Residential development with in-fill affordable housing – 11-23 Rangers Avenue Mosman – Part 1 View Sharing & Heritage Impact

Submission

Name: Keith Rodwell

Residential Development at 11-23 Rangers Avenue, Mosman

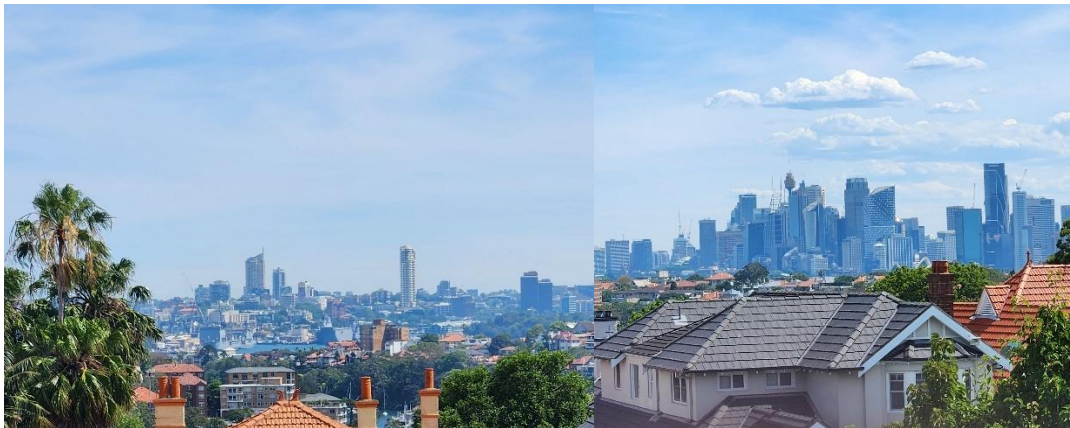
“The properties to the north have distant views available to the Sydney Harbour Bridge, the city skyline and the Mosman harbour”. Distant views is a selective term to diminish the sense of view loss. The Developers submission includes the following photo that validates this deception.

Figure 21 Location Plan showing Potentially Affected Buildings

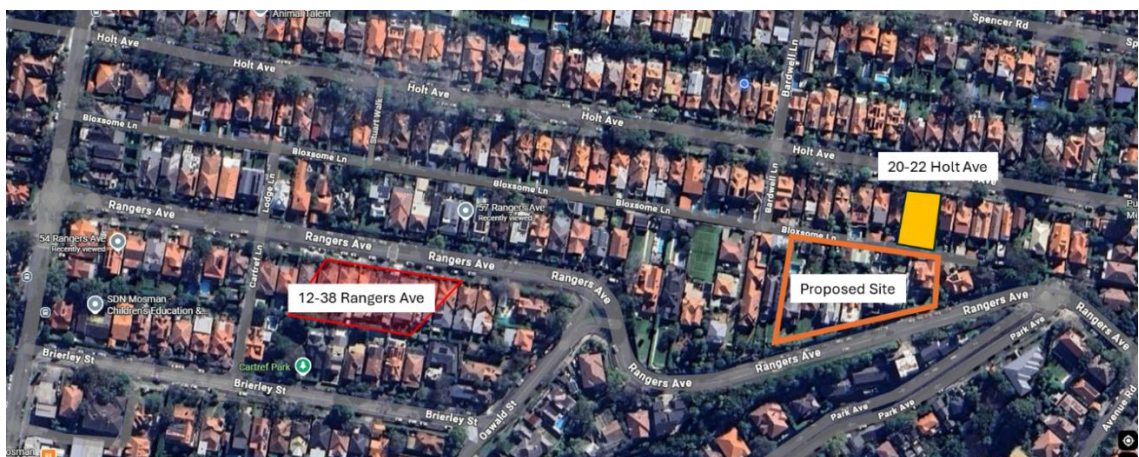
The proposal then provides commentary on the map above describing the effects on:

- 32-38 Rangers Ave
- 12-16 Rangers Ave
- 18-30 Rangers Ave
- 20-22 Holt Ave

12-38 Rangers Ave are not impacted by the proposed development. No reference is made to 8-38 Holt Ave (with the exception of nos 20-22). This omission invalidates the submission and highlights the poor quality of the analysis.

Figure 2 Extract from architectural drawing set - north elevation | Woods Bagot

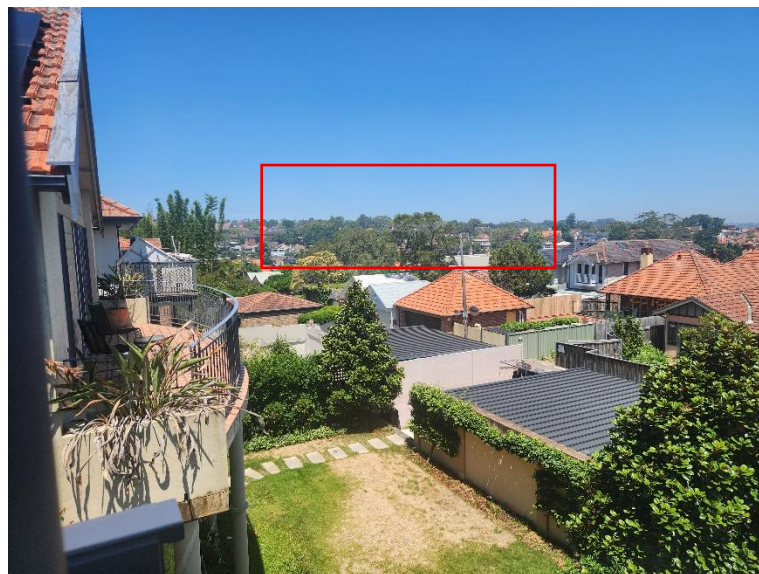
The VIA (page 8) presents a diagram showing the north elevation shown below. It clearly indicates that the houses on Holt Ave adjacent to the site will have a devastating loss of any view. The red lines have been added to represent the equivalent height of residents in Holt Ave on the ground floor and 1st floor of their homes. It also shows a much lesser level of coverage by trees than described in other impact assessments.

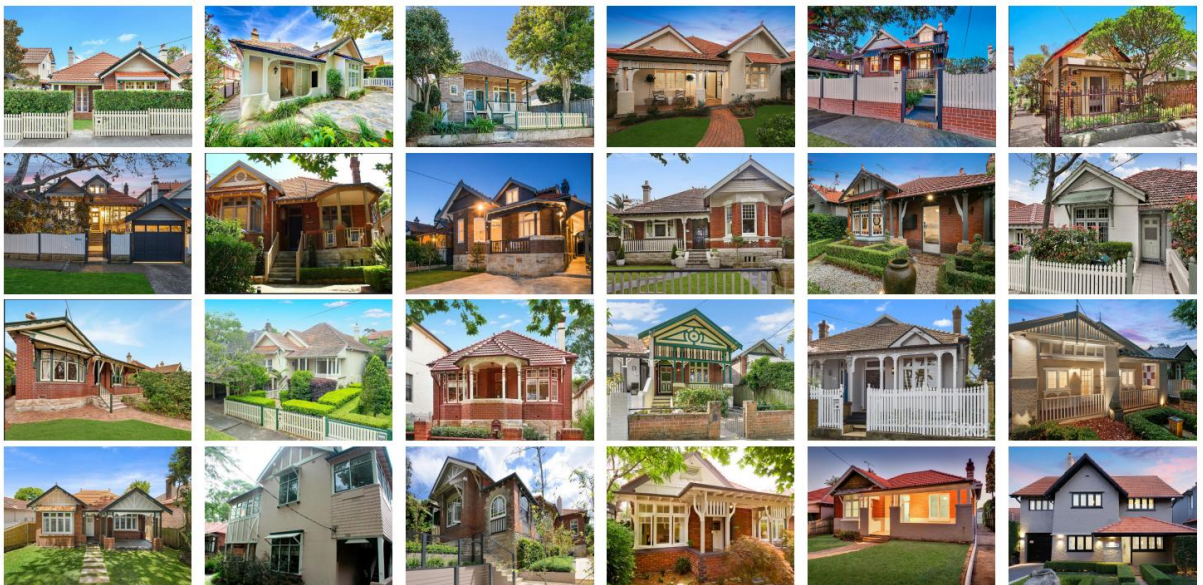
The image presented in Design paper 4 below, clearly contradicts these statements. The Holt Ave dwellings that are part of the Holt Estate HCA are shown at the top of the photo. They are not outside of principal view lines and are materially affected by the bulk and scale of the development that dominates the landscape. The dominating presence of this oversized development on the adjoining properties on Holt Ave at the rear of the development is shown below.

The photo below is from the North side of Holt Ave looking south. The summer photo shows the canopy generated by the trees that line Holt Ave. The plane tree on the left (comprising 50% of the Holt Ave trees) is deciduous and has no leaves for 6 months of the year. The picture on the right has been generated by Chat GPT to reflect the impact of the loss of leaves. The image changes dramatically and the dominating impact of the 6-storey development overlooking these properties will clearly be visible and detract from the heritage character of the Holt Estate HCA.
